City of Alachua

Planning & Community Development Department Staff Report

SUBJECT: A request for a Special Exception Permit for a large-scale retail establishment greater than or equal to 80,000 square feet

CITY OF ALACHUA
STAFF REPORT: WAL-MART #3873
SPECIAL EXCEPTION PERMIT
(LARGE SCALE RETAIL ESTABLISHMENT ≥ 80,000 SQ. FT.)

Illustration 1: Sheet C-6 of the Proposed Site Plan

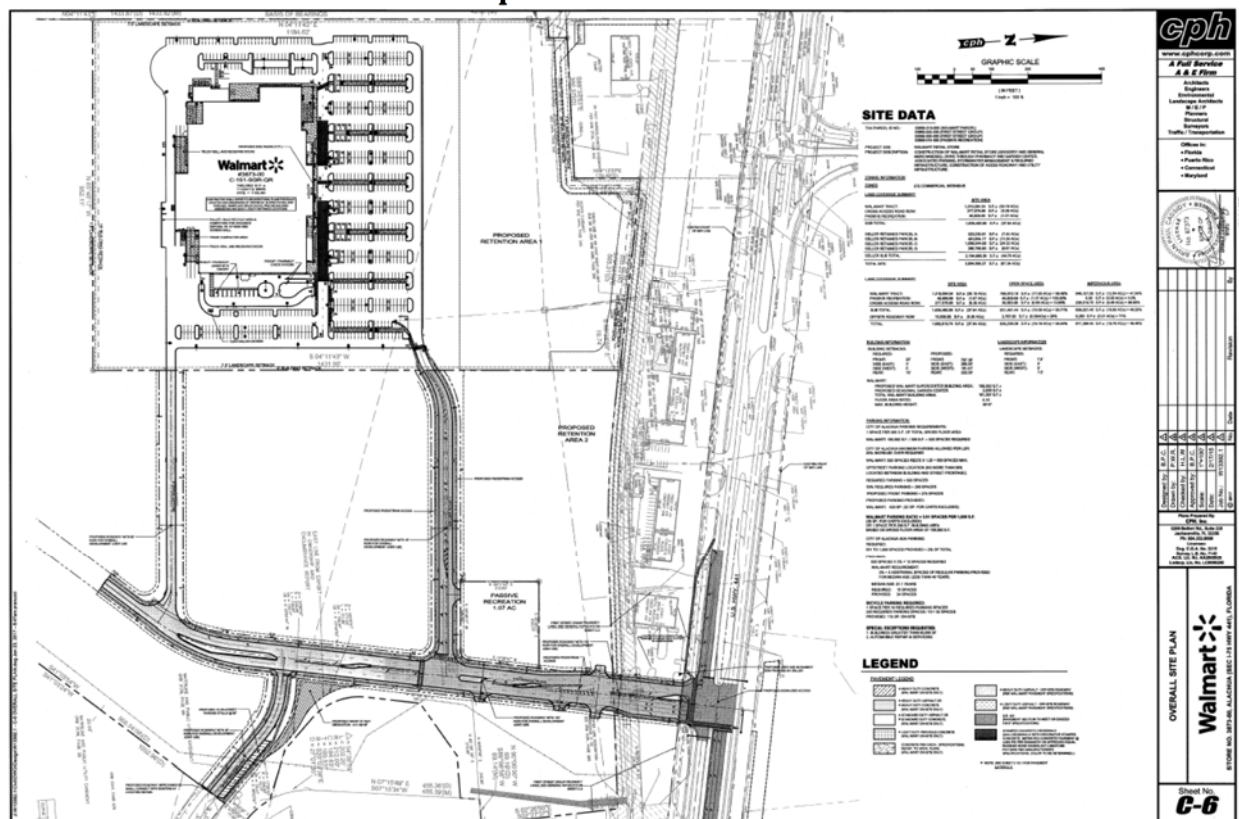
(g) Sheet C-6: Add Tax Parcel No. 03066-000-000 under Site Data.

(h) Sheet C-6: Impervious Area for parcel currently labelled “City dedicated parcel” is 0 square feet. Revise accordingly.

(i) Sheet C-6: There is a typographical error under “Special Exceptions Requested.”

- (j) Sheet C-6: There is a typographical error under “Conditions,” first bullet.
- (k) Sheet C-6: There is a typographical error under “Conditions,” third bullet, second line (“location” should be plural.)

- (l) Sheet C-6: “Conditions,” third bullet: verify the information is correct pertaining to rainfall to be treated.
- (m) Sheet C-6A: Keynotes: Identify detail sheet where detail for each keynote is provided.

Illustration 1: Sheet C-6 of the Companion Site Plan Application, Showing Location of Existing/Proposed Sidewalks

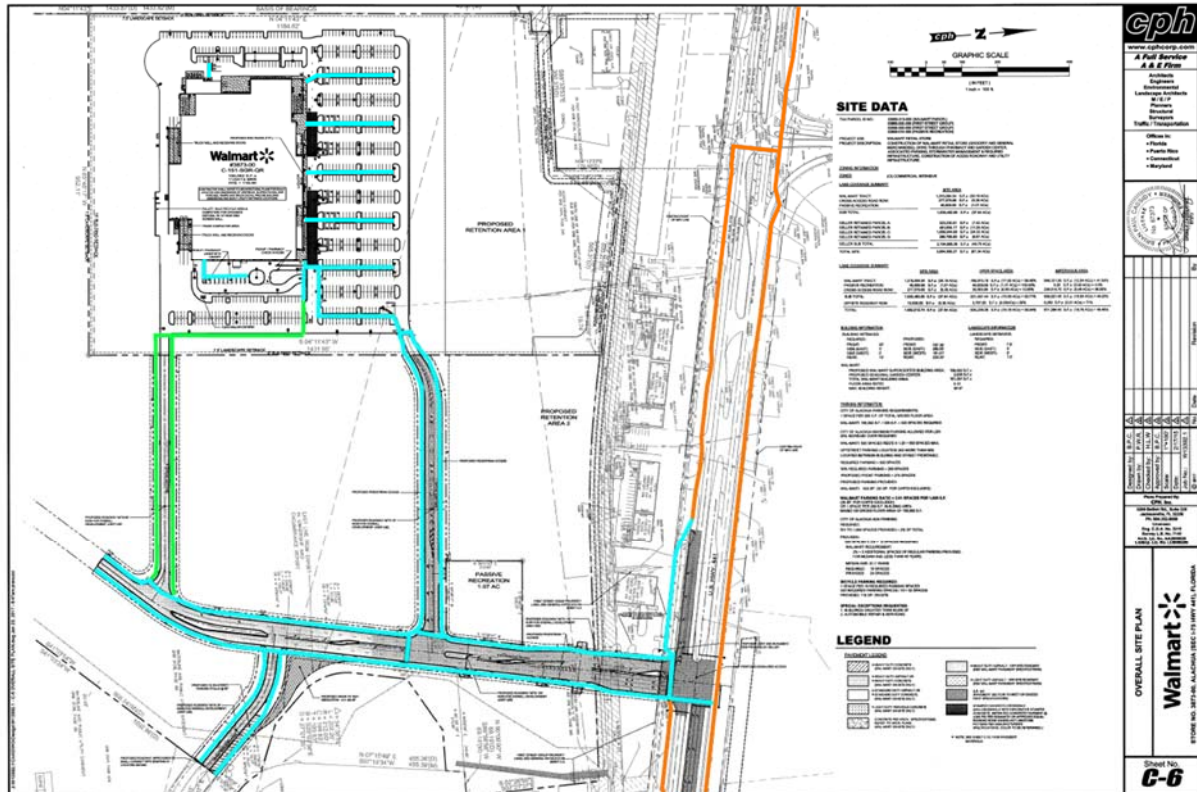
148th Drive. These connections would increase connectivity and enhance pedestrian access to the proposed development, and are shown on Illustrations 1 and 2 in green (NOTE: the location of sidewalks to be required by Proposed Condition #1 as shown on Illustrations 1 and 2 are depicted as an approximation of the location of sidewalks to address the condition. Final design may result in slight adjustments in location to meet site constraints.)

- a. Provide five foot (5’) sidewalks within the right of way of “Seller Road 2” to the north and south the road, as depicted and labeled on Sheet C-6B of the Site Plan, and to provide a 5 foot (5’) sidewalk and any necessary crosswalks from the terminus of the right-of-way of “Seller Road 2” connecting said sidewalks along “Seller Road 2” to the primary customer entrances of the development. Sidewalks shall be designed and constructed to comply with the City of Alachua Land Development Regulations and all applicable Florida Department of Transportation (FDOT) standards; and,

- b. Provide funding to the City for a five foot (5’) sidewalk along the south right-of-way line of the NW 151st Boulevard, from the existing terminus of the sidewalk at the intersection of NW 151st Boulevard and NW 148th Drive to the existing terminus of NW 151st Boulevard, which is contiguous to the location of proposed sidewalk improvements as depicted on Sheet C-6B of the companion Site Plan application. A Professional Engineer registered in the State of Florida shall prepare the calculation of the funding amount. The calculation shall include the cost of all materials and labor to construct a sidewalk which complies with the City of Alachua Land Development Regulations and all applicable Florida Department of Transportation (FDOT) standards. Funding required by this condition shall be provided to the City prior to applying for a building permit for the building shown on the companion Site Plan application.
